RE: NHTSA Recall Number 08E-064; Supplemental to SKF's Notice dated October 16, 2008

# SAFETY RECALL NOTICE TO END USERS

NHTSA Recall #08E-064 of SKF BR930361 hub bearing assembly; SKF Recall # PRO 08-029US/CA

Figure 1 Defective

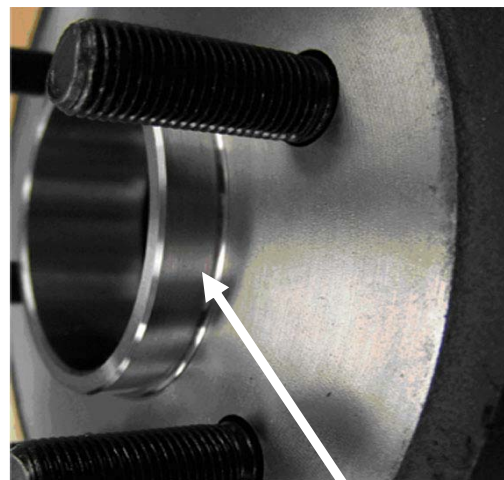
The rotor pilot for the hub bearing assembly was made too long. This results in the wheel to not be seated fully against the hub flange face during mounting. Improper seating of the wheel can result in excessive vibration, brake rotor noise, difficulty removing the wheel after installation and operation of the vehicle, and possibly wheel-end separation during vehicle operation. **Should the wheel-end separation occur, the driver could lose control of the vehicle, possibly resulting in a crash.**

1. Raise and support the vehicle following the manufacturer's guidelines and remove the front wheel.
2. Carefully examine the center brake rotor pilot depth. ***The affected hub bearing assembly will have a noticeable visible step just above where the brake rotor is seated.*** Refer to Figures 1 & 2. Figure 1 illustrates the incorrectly machined hub and brake rotor mounting set up. Figure 2 illustrates the correctly machined hub and brake rotor mounting set up.

If you have identified a hub bearing assembly that is defective, remove the defective hub assembly and replace it with a non-defective replacement hub assembly using the manufacturers recommended repair procedures. Return the defective hub assembly to the place of purchase for reimbursement as identified above.

Figure 1 Defective

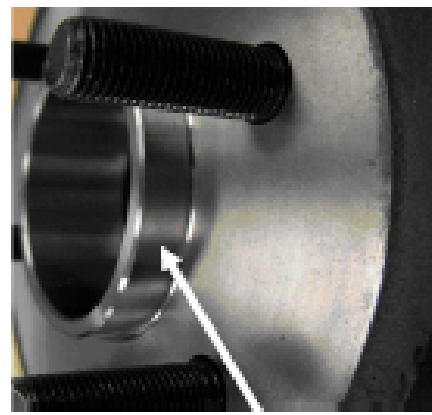
2. Carefully examine the center brake rotor pilot depth. *The affected hub bearing assembly will have a noticeable visible step just above where the brake rotor is seated. Refer to Figures 1 & 2. Figure 1 illustrates the incorrectly machined hub and brake rotor mounting set up. Figure 2 illustrates the correctly machined hub and brake rotor mounting set up.*

3. If you have identified a hub bearing assembly that is defective, remove the defective hub assembly and replace it with a non-defective replacement hub assembly using the manufacturers recommended repair procedures. Caution: Verify that the replacement SKF BR930361 is not a defective part by repeating step 2 listed above.
